SUBJECT: Forwards corrected Page 1 to attachment to util 811021, ltr responding to NRC 810821, ltr re pressurized thermal shock to reactor pressure vessels.

Pressurized Thermal Shock to Reactor Pressure Vessels

RE: Turkey Point Nuclear Power Plant Unit No. 4: Reactor Vessel Embrittlement and Surveillance Program

Data Reproduced from Table on Page 3 at Wall Location 1/4T,
Report by E. B. Norris, "Reactor Vessel Material Surveillance
Program for Turkey Point Unit No. 4: Analysis of Capsule T",
Southwest Research Institute Technical Report No. 02-4221,
June 1976.

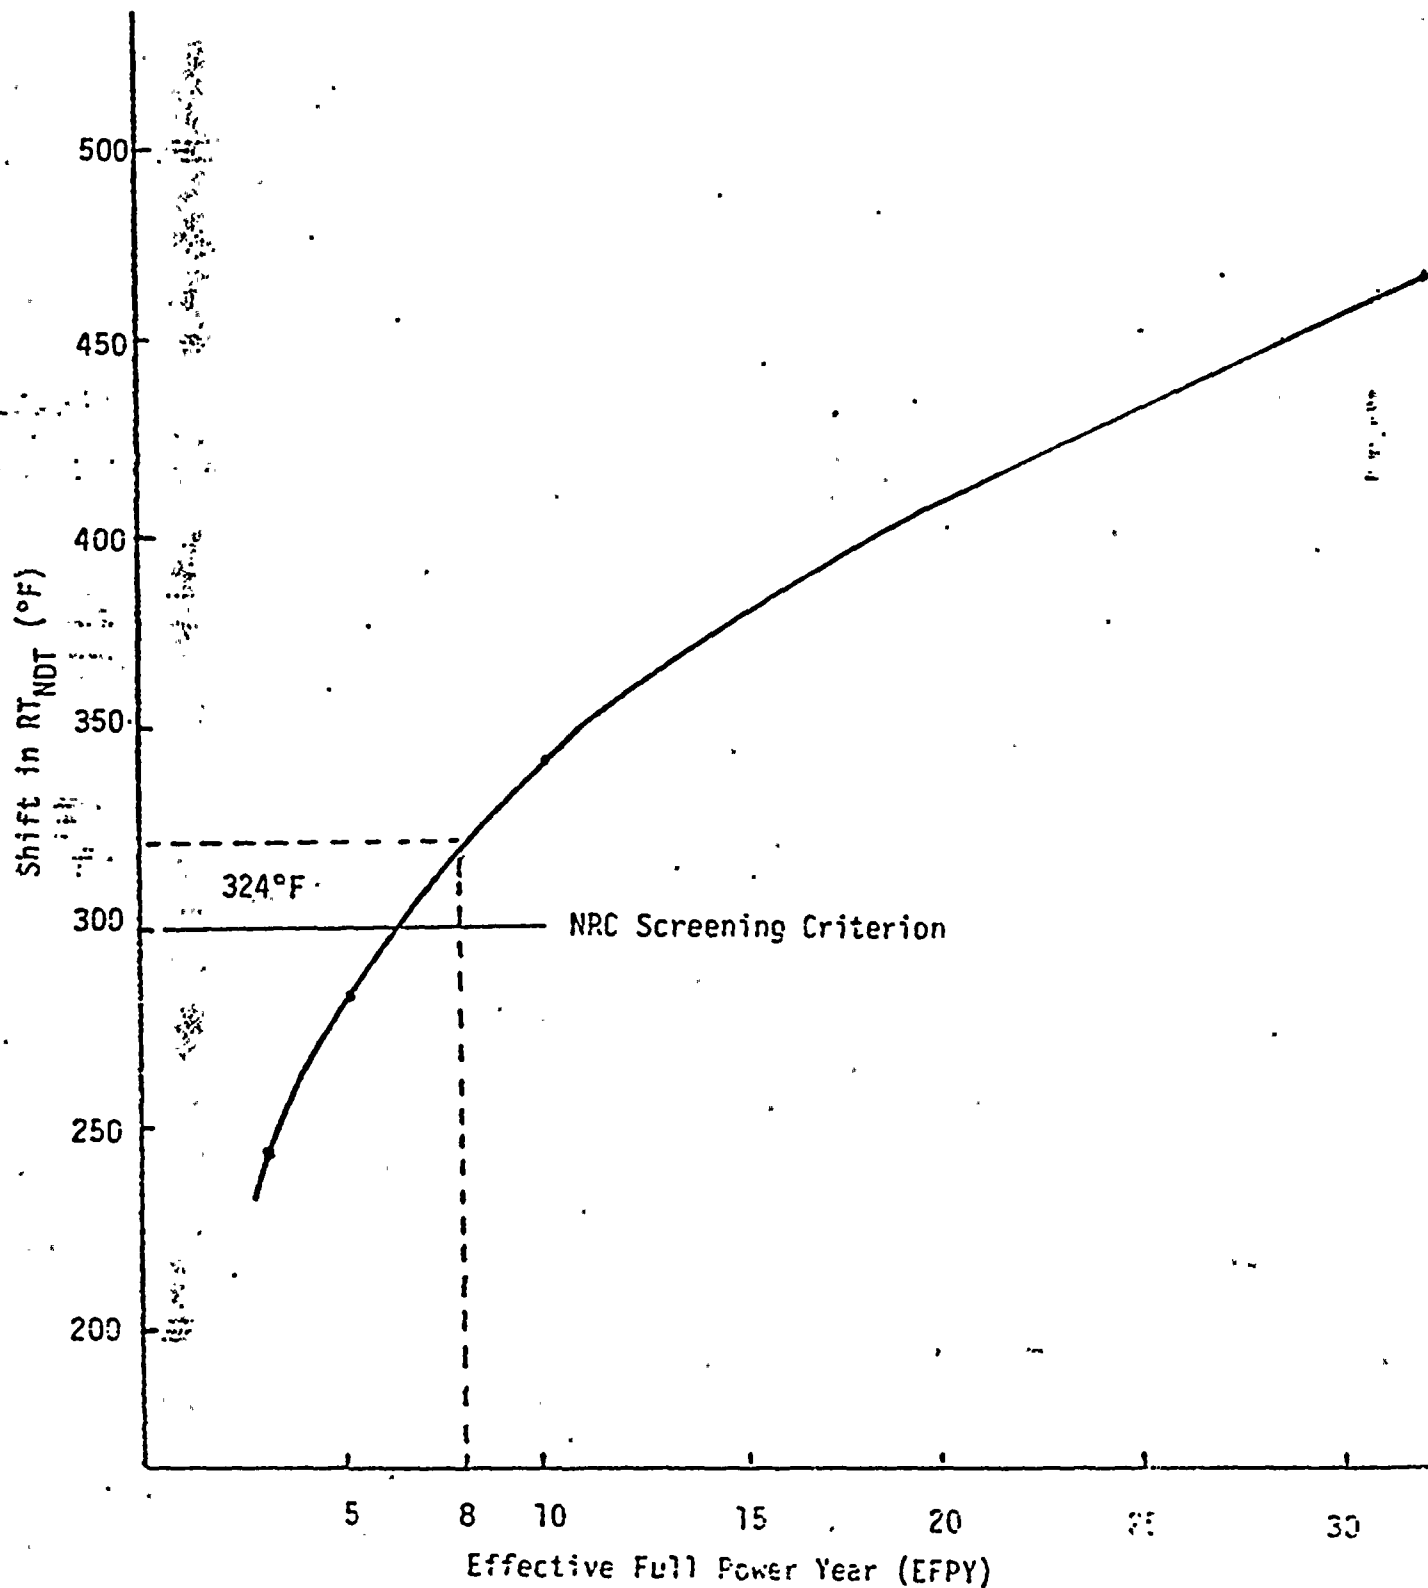
Based on the RPV material surveillance methodology, SWRI [1] estimated the shift in RT_{NDT} for Turkey Point Unit No. 4. The results pertaining to wall location 1/4T based on the data of Capsule T in terms of EFPY are summarized graphically on the sheet attached to this letter. The shift in RT_{NDT} is found to be approximately 324°F at 8 EFPY. This is beyond the NRC screening value of 300°F.
